TEXAS COMMISSION ON ENVIRONMENTAL QUALITY  
**AGENDA ITEM REQUEST**  
for State Implementation Plan Revision Adoption

**Subject:** Commission Approval for Adoption of the Rusk-Panola Attainment Demonstration State Implementation Plan (SIP) Revision for the 2010 Sulfur Dioxide (SO<sub>2</sub>) National Ambient Air Quality Standard (NAAQS)

Rusk-Panola 2010 SO<sub>2</sub> NAAQS Attainment Demonstration SIP Revision  
SIP Project No. 2020-057-SIP-NR

**RESPONSE TO COMMENTS RECEIVED CONCERNING THE  
RUSK-PANOLA ATTAINMENT DEMONSTRATION STATE  
IMPLEMENTATION PLAN (SIP) REVISION FOR THE 2010  
SULFUR DIOXIDE (SO<sub>2</sub>) NATIONAL AMBIENT AIR  
QUALITY STANDARD (NAAQS)**

Figure 4-7: Controlling Scenario Model Results

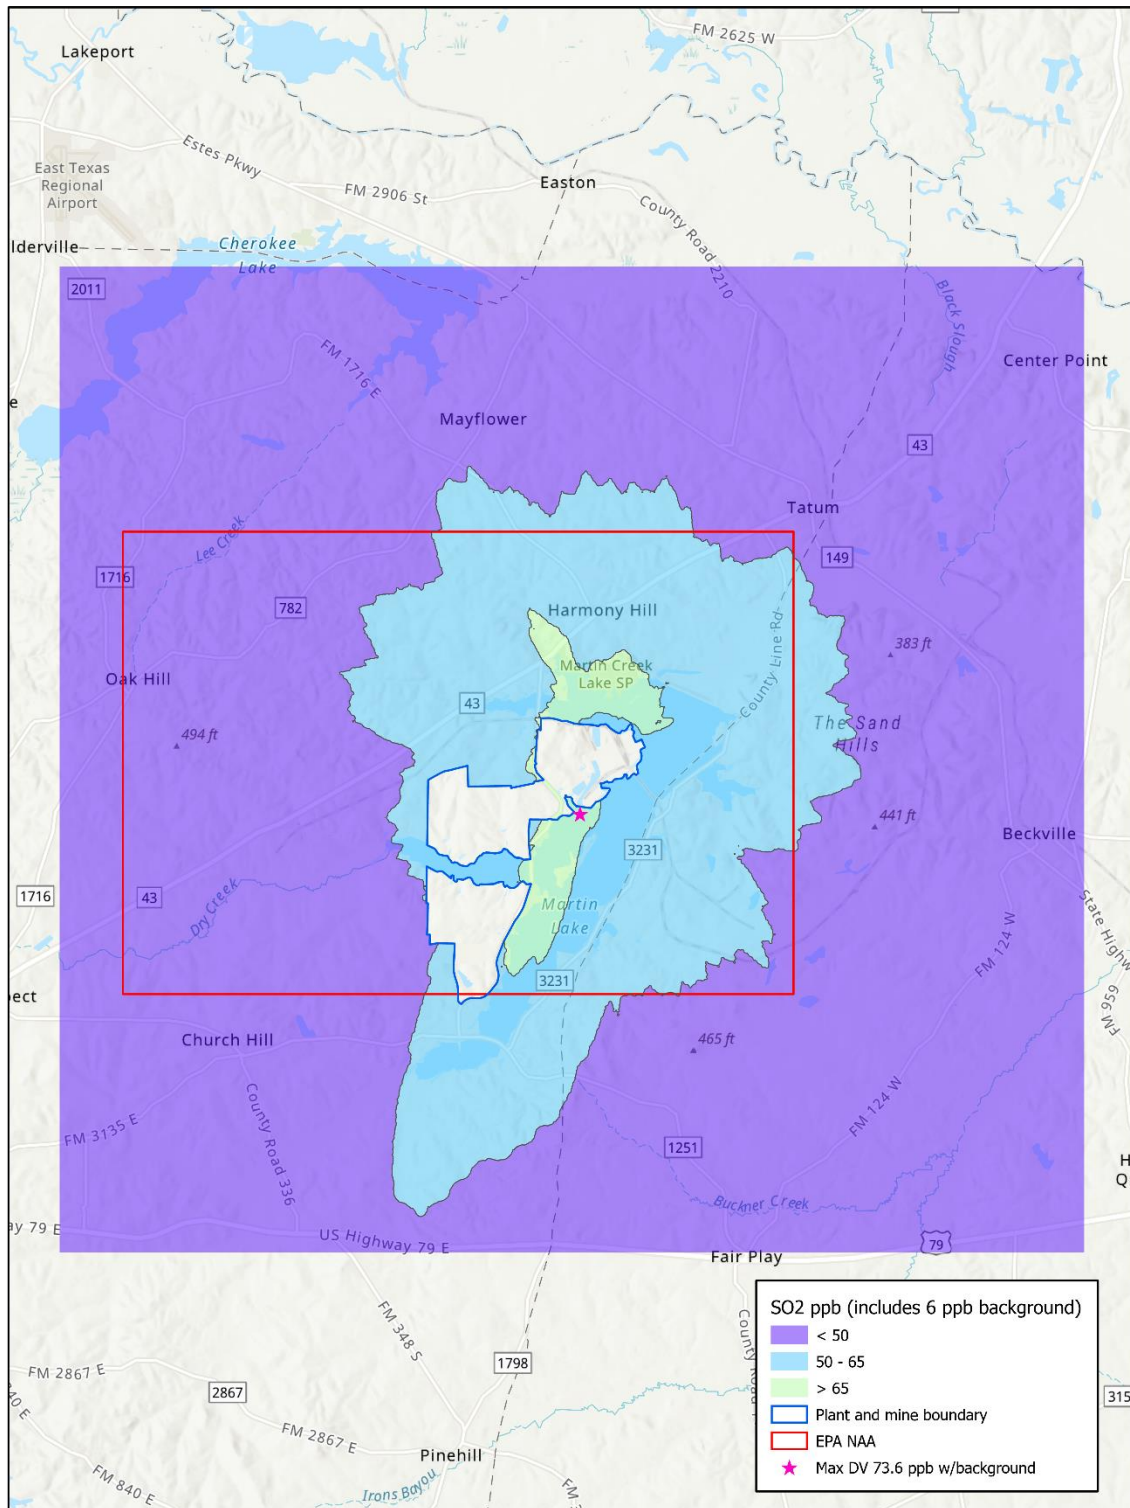
The EPA commented that the proposal did not include information to support the TCEQ's use of Vistra's (Luminant) estimate that the planned control measure would result in a 15% reduction in stack exit velocity. The EPA requested the supporting information be included to facilitate its review. The EPA further commented it is unclear if a 15% reduction should be applied to the stack exit temperature in addition to the velocity since reduction in temperature would reduce plume buoyancy and increase the modeled design value. The EPA provided details of a modeling sensitivity where the stack exit temperature was reduced by 15% from the values modeled by the TCEQ to demonstrate resulting increase in modeled design value.

**The TCEQ performed additional modeling to ascertain the extent of the theoretical situation described in this comment. Through this modeling and the agreed order development process, the TCEQ identified additional limitations to enhance the protectiveness of this SIP revision under the conditions described by the EPA in this comment. In addition to the proposed emissions cap for the combined three electric generating facility (EGF) boilers, a lb/MMBtu emission limit has been added for each individual boiler. The TCEQ took into account the 0.33 lb/MMBtu one-hour critical emission factor (CEF) limit and a one-hour critical emissions value (CEV) cap of 8,208 lb/hr for the three EGF boilers that are the basis of the compliance limits to determine the final set of 42 modeling scenarios used to demonstrate attainment of the NAAQS under different load levels and associated varying stack parameters. Details of the TCEQ's identification of modeling scenarios and the resulting modeled design values are documented in Chapter 4 and Appendix K of this SIP revision.**
